# Access Compliance Report

## Public Rights-of-Way

### (Curb Ramps)

| Intersection ID: 30456 | Main Street: STEELE_MEADOW_RD | Cross Street: WALLAND_LN | Location: SW           |

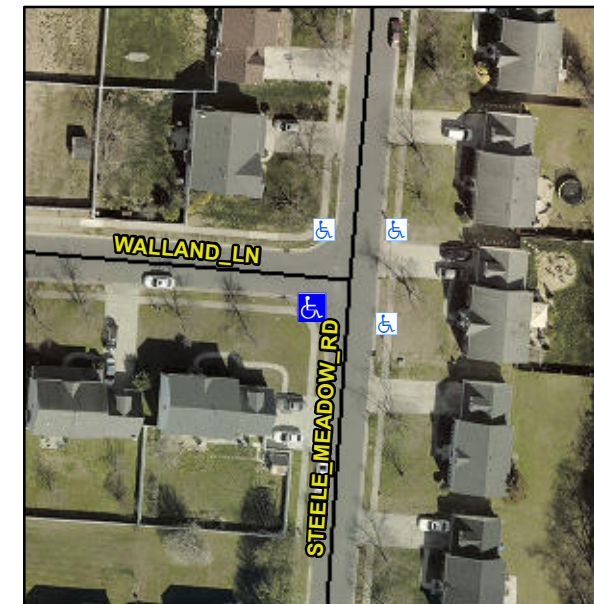
| ADA ID: D36BB249EF29   | Ramp Type: BlendTrans2        | Initial Pass/Fail: Pass  | Overall Compliance: No |

**Not Found, R305.1.4, R305.2**

| Compliance | Description           | Data   | Compliance | Description                 | Data   |
|------------|-----------------------|--------|------------|-----------------------------|--------|
| N/A        | Landing X Slope (%)   | N/A    | No         | DWS Full Width?             | No     |
| N/A        | Landing Curb? (Y/N)   | No     | No         | DWS Offset (in)             | 5.0    |
|            |                       |        | No         | Curb Slope (%)              | 25.5   |

**Remove & Replace Curb Ramp With Two New Directional Ramps or Equivalent.**
